DOCUMENT 00 90 00
ADDENDUM

ADDENDUM: 2

PROJECT: WESTERN TECHNICAL COLLEGE
SPARTA PUBLIC SAFETY TRAINING SIM CITY
11177 COUNTY HWY 1
SPARTA, WISCONSIN 54656
PROJECT NO. 25039

FROM: HSR Associates, Inc
100 Milwaukee Street
La Crosse, WI 54603
(608) 784-1830

1 SITE PLAN
1" = 30'-0"

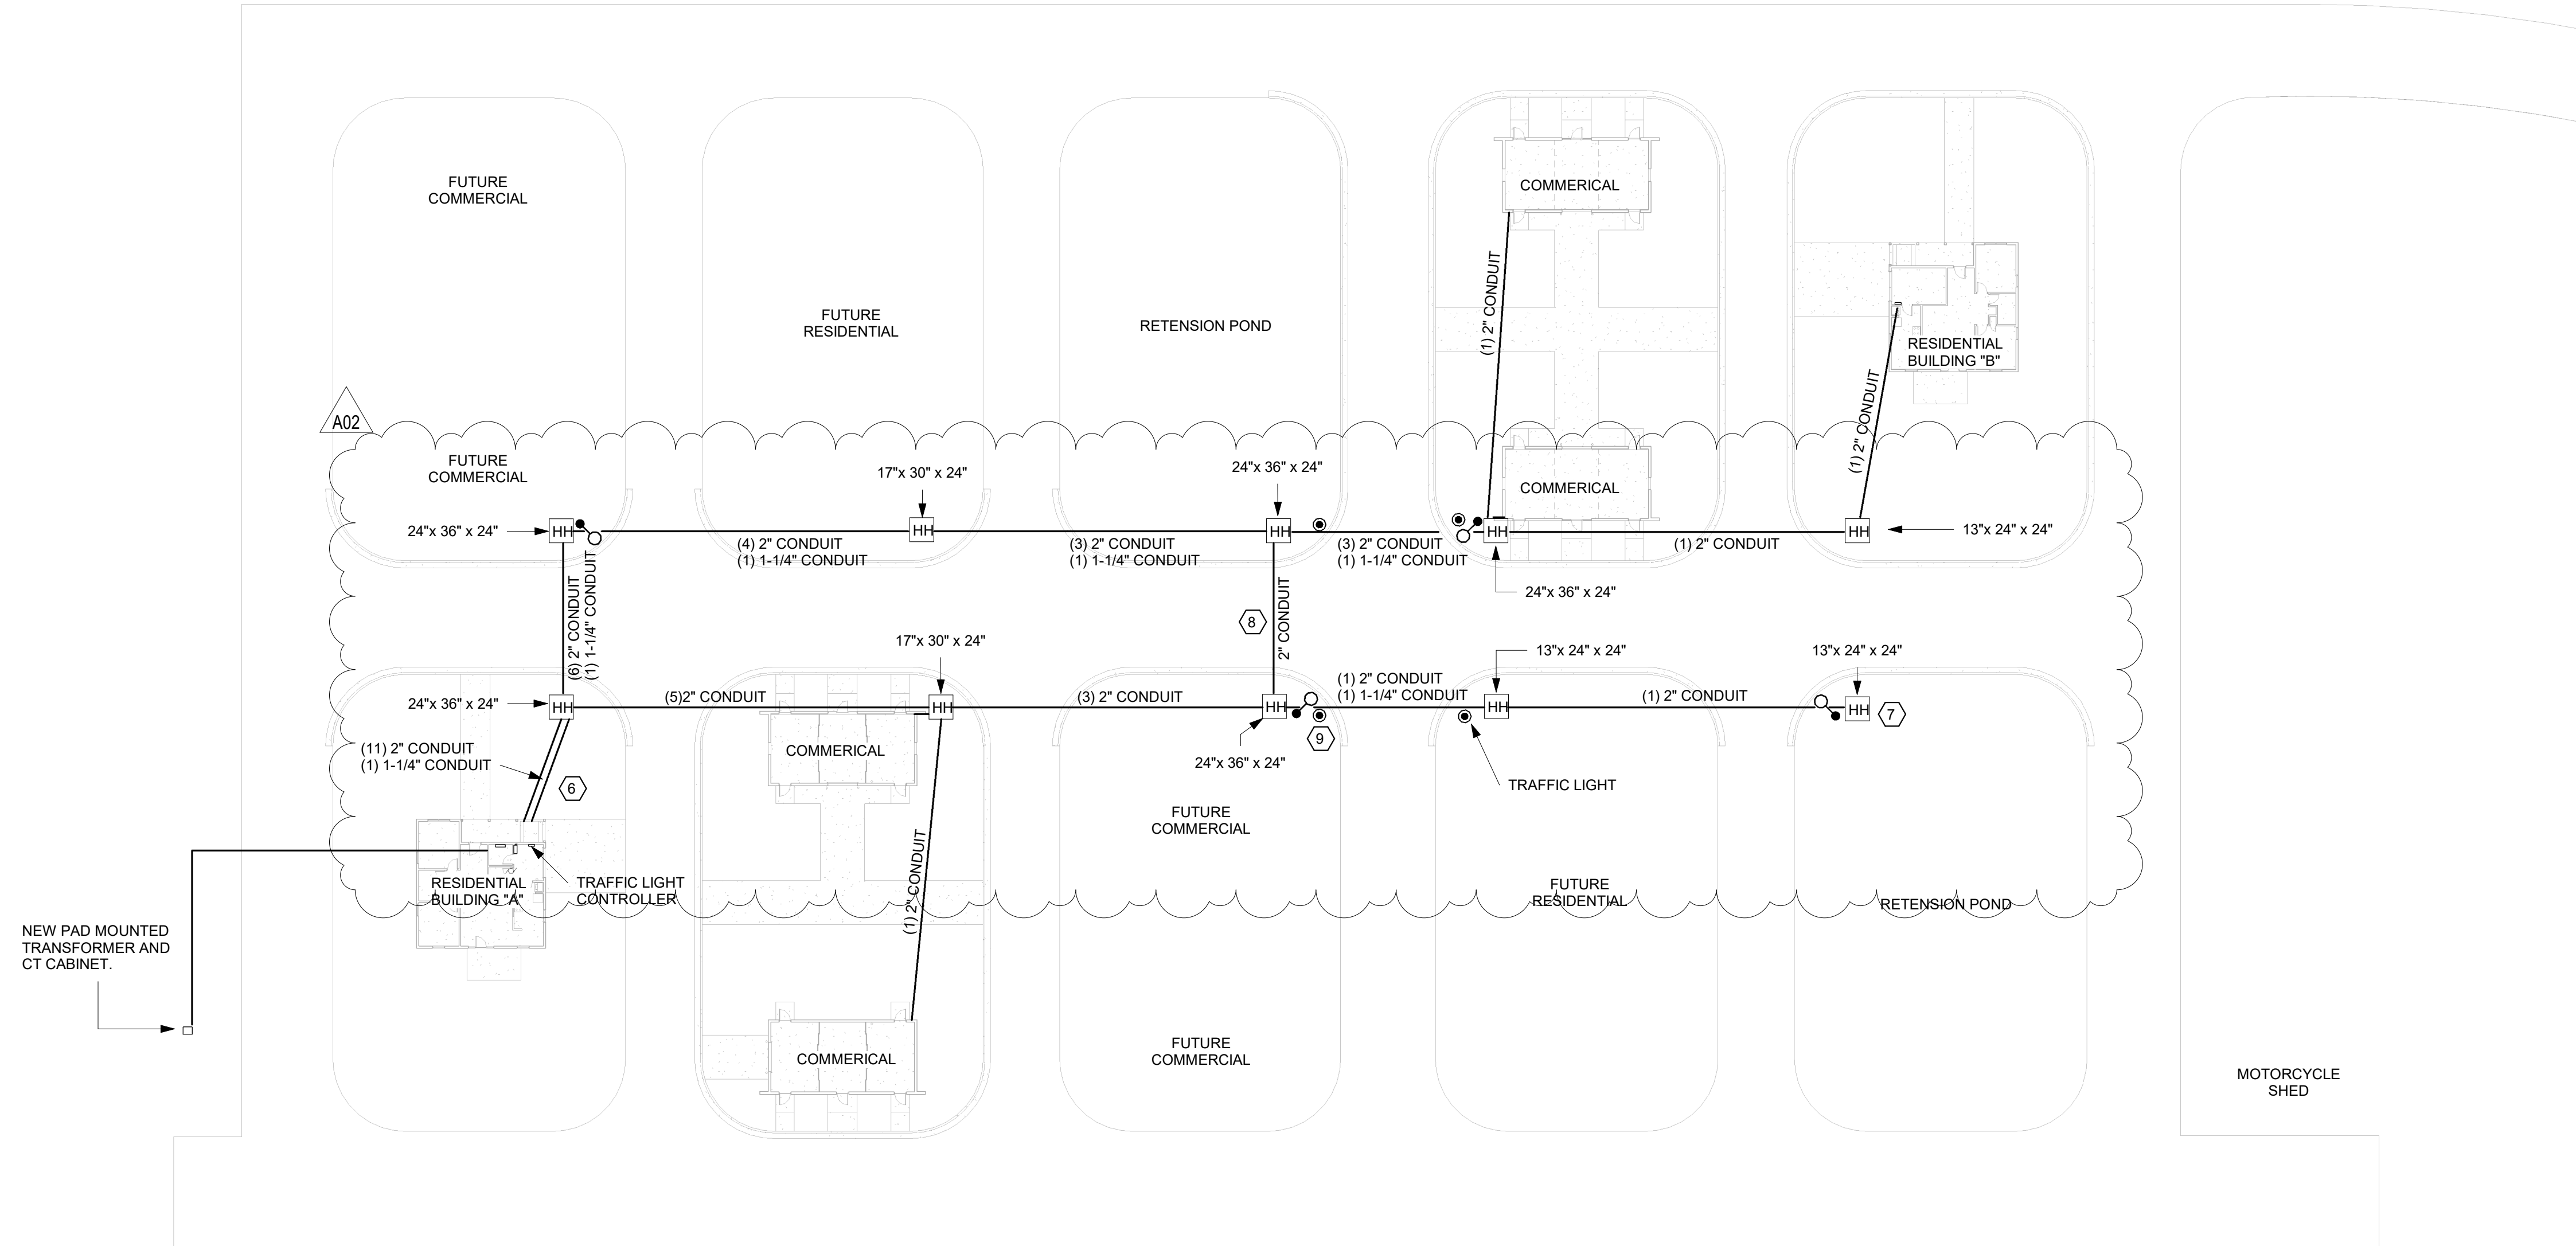
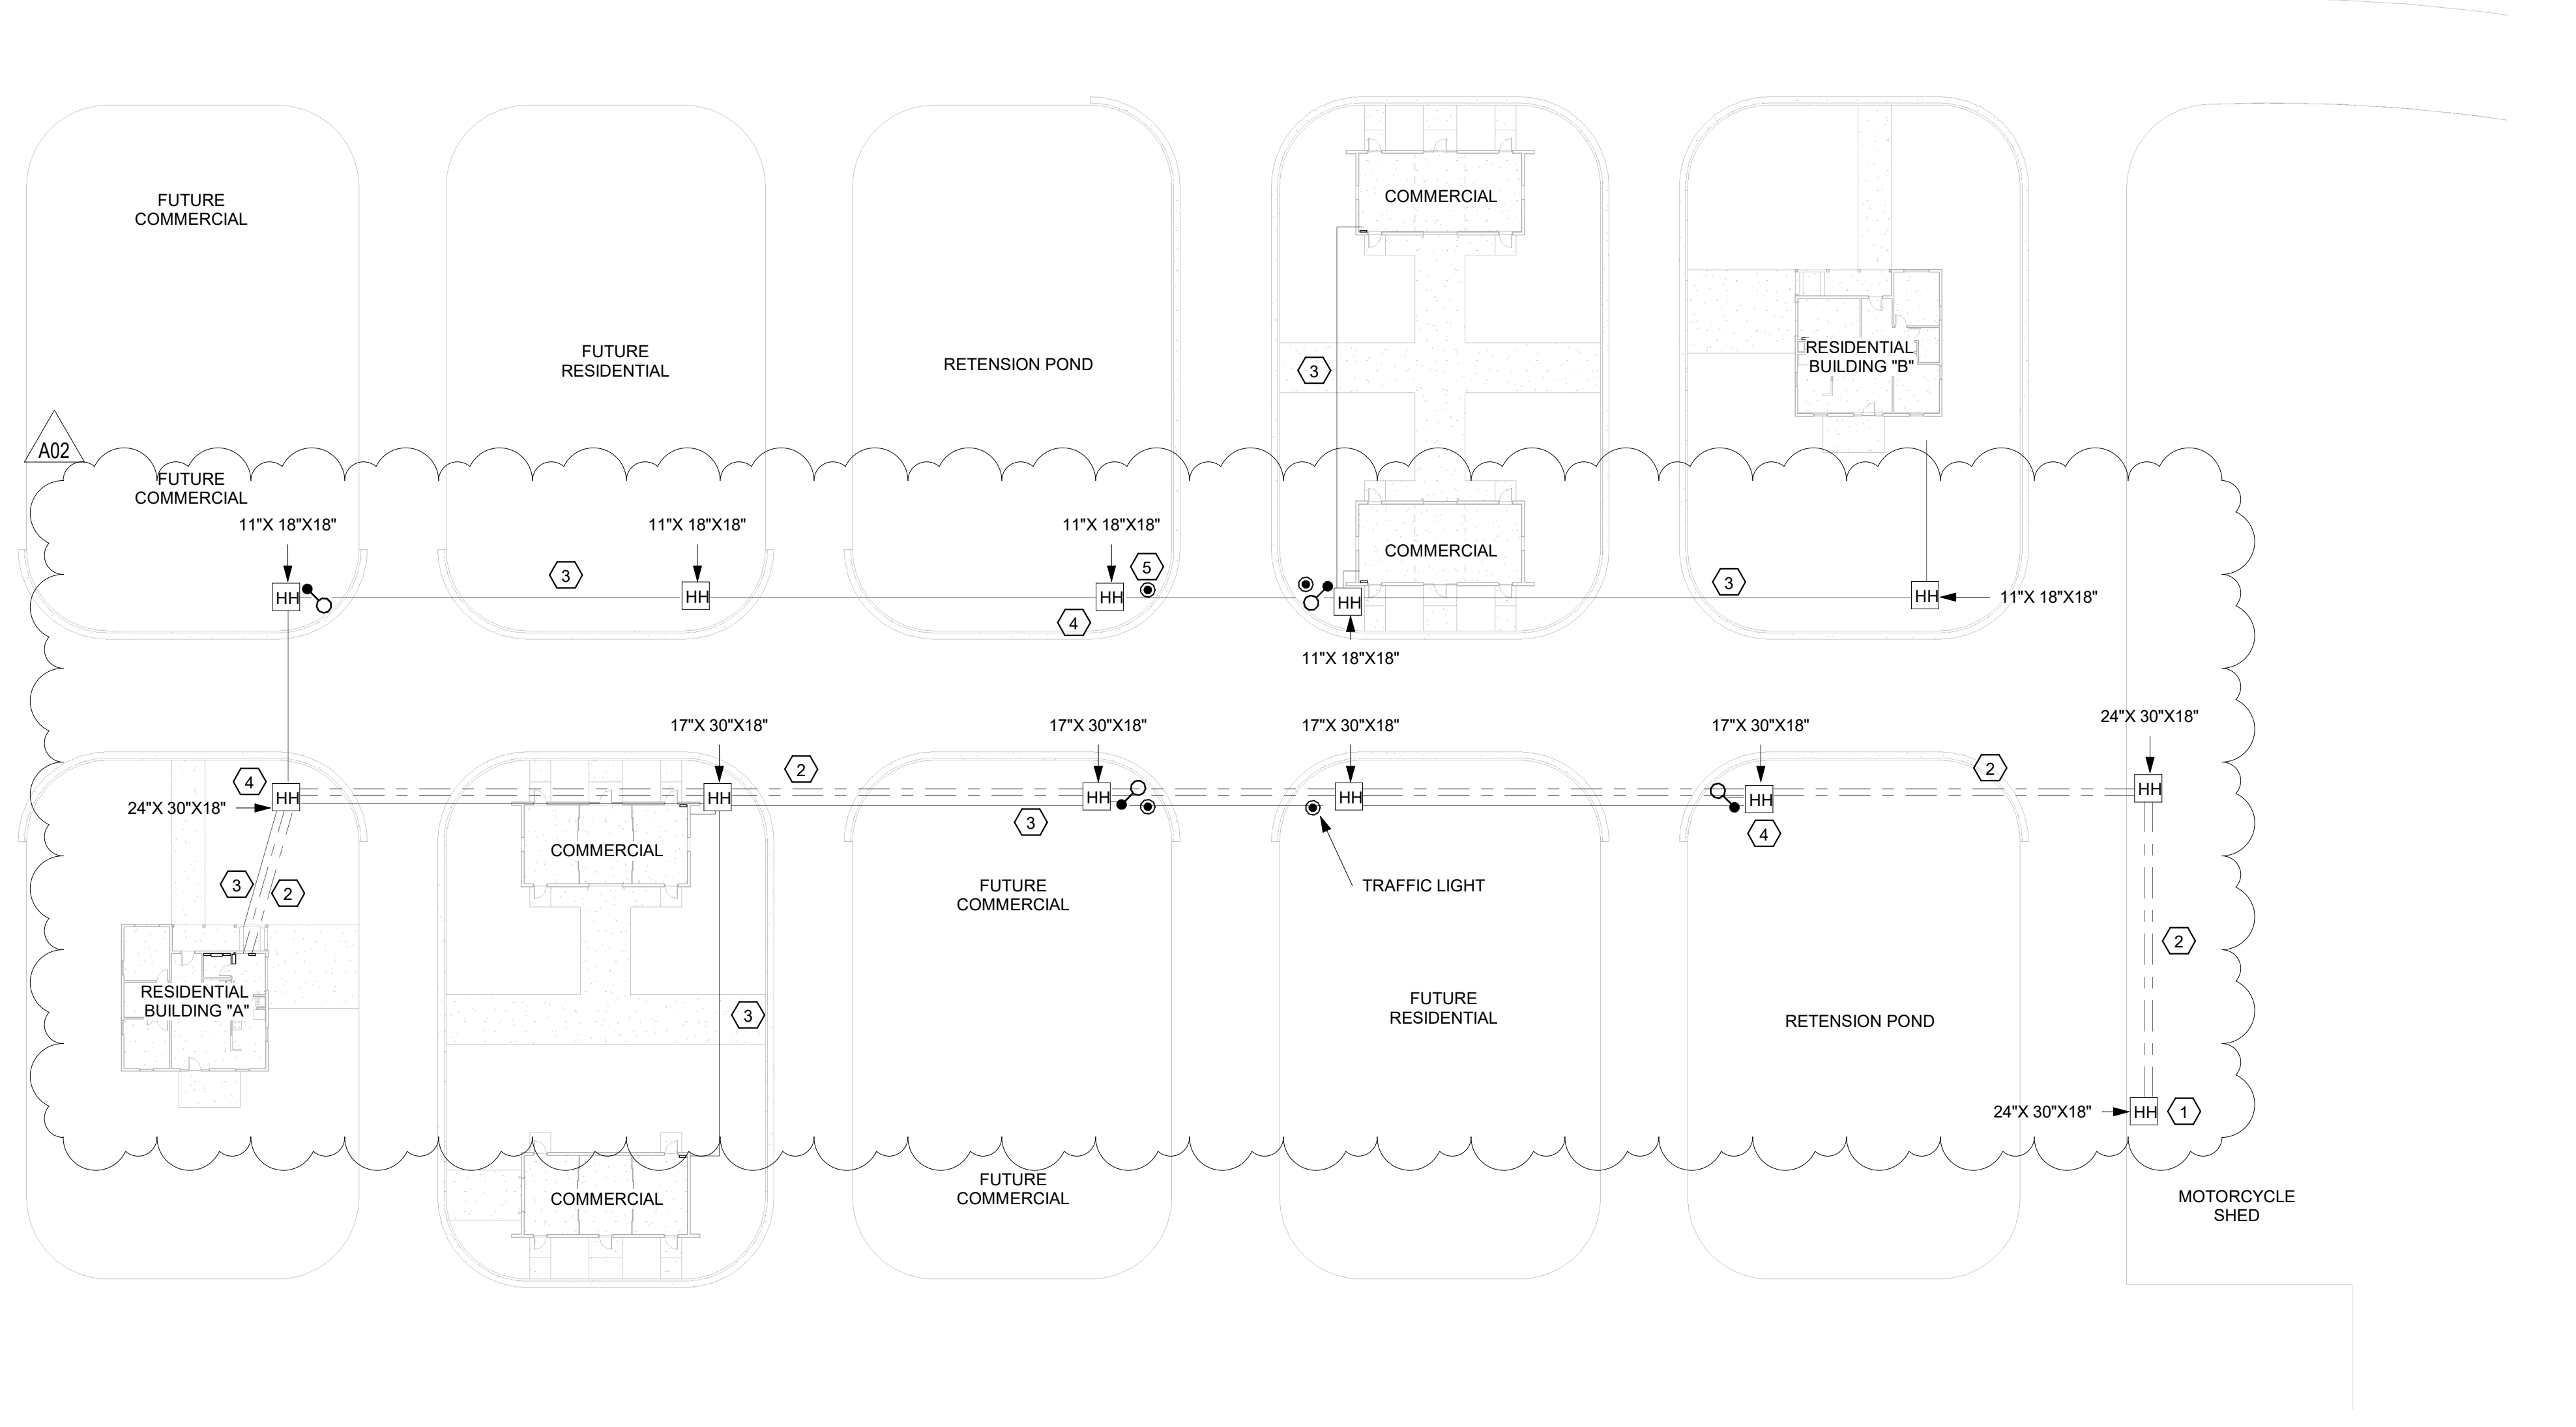
- b. Added requirements for handholes.
 - c. Revised requirements for conduits.
